STAFF REPORT ADDENDUM

APPLICATIONS RZ 2009-PR-022

APPLICANT: James Hollingsworth

PROPOSAL: Rezone from the R-1 District to the R-4 District to allow the construction of three single-family detached dwellings.

SHEET
5
OF
10

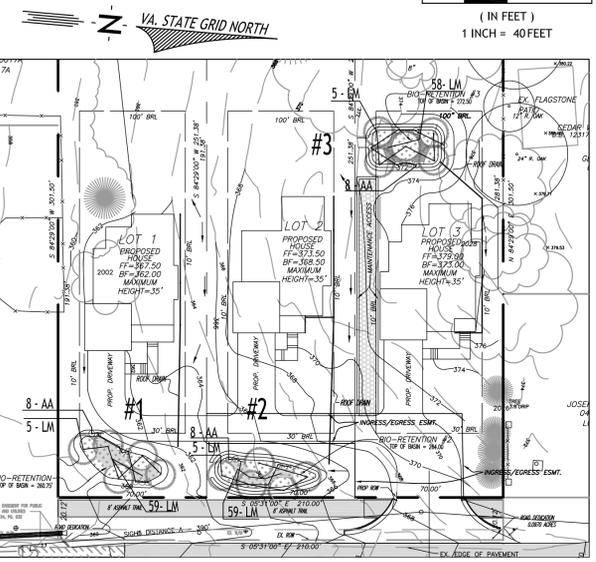
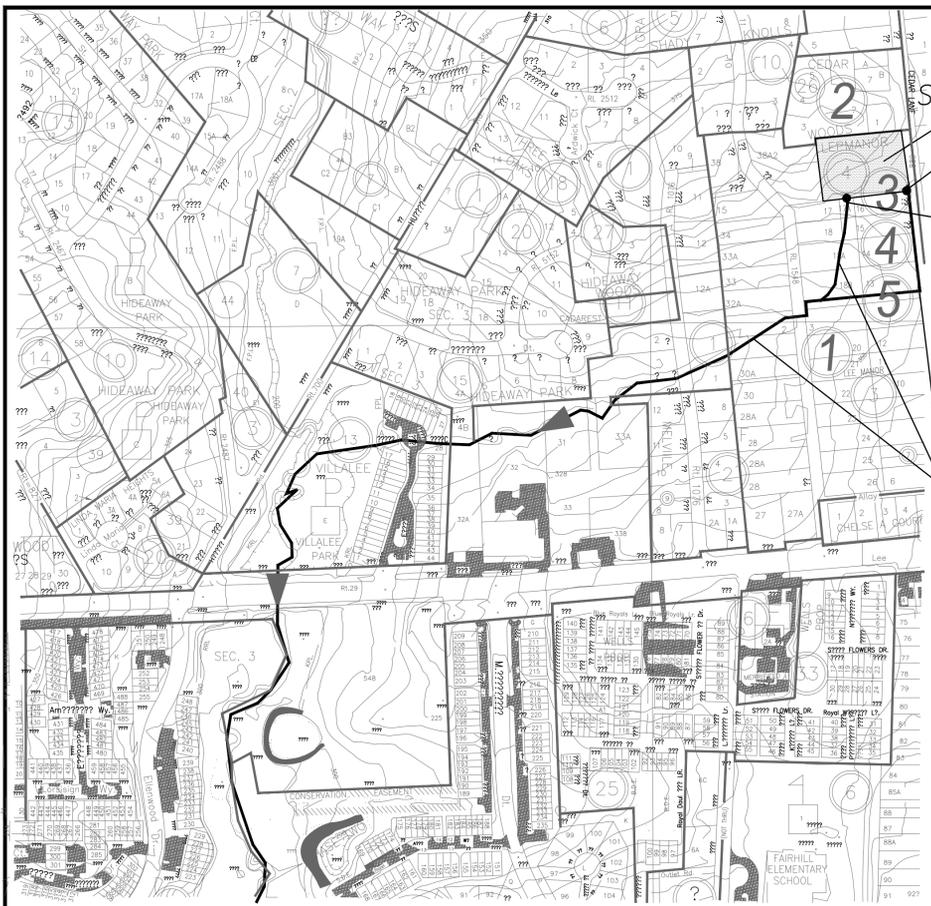
- new infiltration tests may be necessary to meet current PFM requirements (PFM 4-0700),
- there is likely to be stone underneath the filters to a depth of about 8 feet, notwithstanding the diagram on Sheet 5 (PFM 6-1307.6);
- the volume of the 1-year storm from the entire site must be detained for 24 hours as part of the Detention Method requirements (PFM 6-0203.4C(1)(i)), and
- it must be demonstrated the bioretention facilities have the detention volume necessary to meet the requirements of the detention method and, if necessary, to meet the requirements of PFM 6-0203.5 as mentioned above.

SHEET
6
OF
10

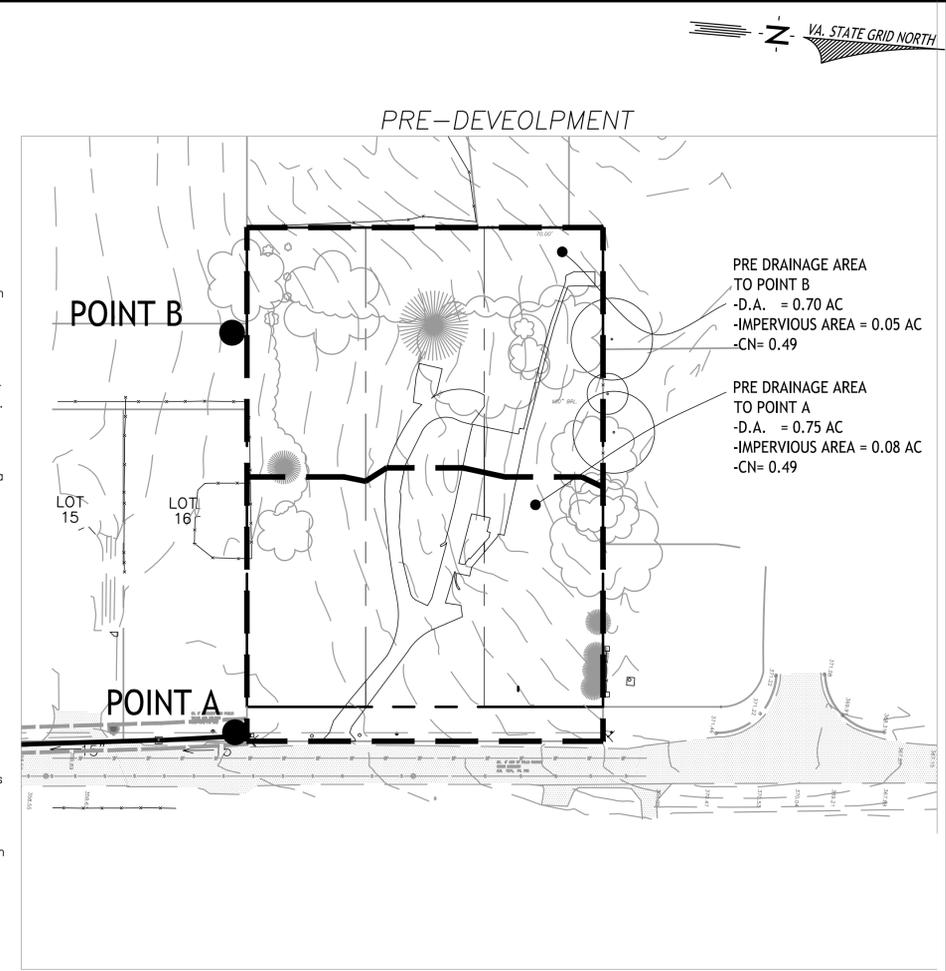
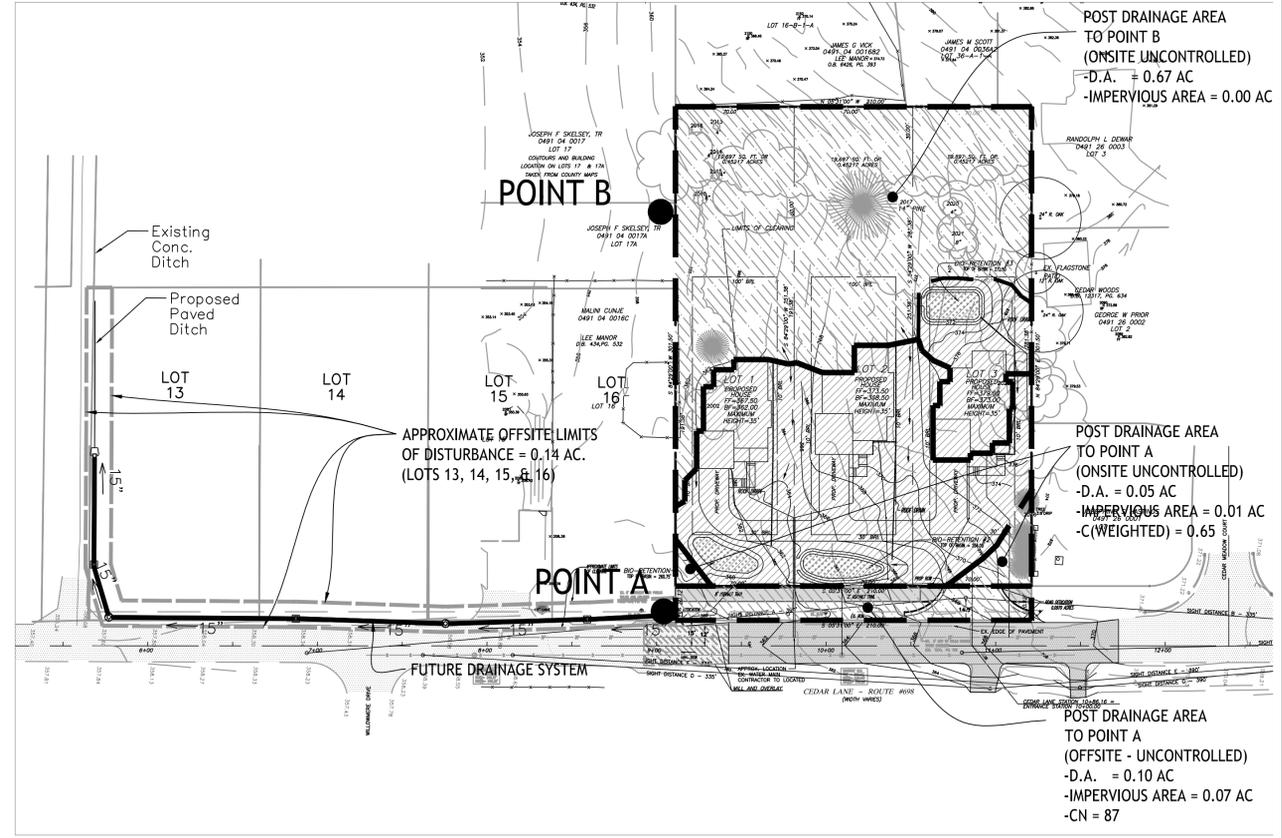
The applicant has revised Sheet 6 of the GDP to depict an open and closed stormwater drainage system that is to be installed along the Cedar Lane frontages of Lots 13 through 16 to the south of the subject property and along the southern frontage (Emil Way) of Lot 13. A 15-inch underground pipe is shown to be installed along Cedar Lane from the boundary of the subject site and adjacent Lot 16, to the intersection of Cedar Lane and Emil Way. The 15-inch underground pipe installation is shown to continue along Emil Way, along a portion of the frontage of Lot 13 where it will connect to a proposed paved ditch along the remainder of the frontage of Lot 13. At the western border of Lot 13 the proposed paved ditch will connect to an existing concrete ditch along Emil Way which drains to a box inlet at the corner of Emil Way and Maple Lane and to a 30-inch pipe. The applicant has obtained notarized letters from the property owners of Lots 13, 14, 15, and 16 that grant the applicant permission to apply for all the necessary permits with VDOT and Fairfax County to install the proposed drainage system.

An offsite drainage improvement is proffered along lots 13, 14, 15 and 16 adjacent to the subject Property and annotated on sheet 6 of the GDP dated August 21, 2013. The four property owners of lots 13-16 have each signed notarized letters of permission granting the Applicant permission to apply for the necessary permits to construct the offsite drainage improvement with VDOT and FCDOT. These notarized letters also grant the Applicant permission to obtain any necessary easements for the purpose of installing the proposed offsite drainage system.
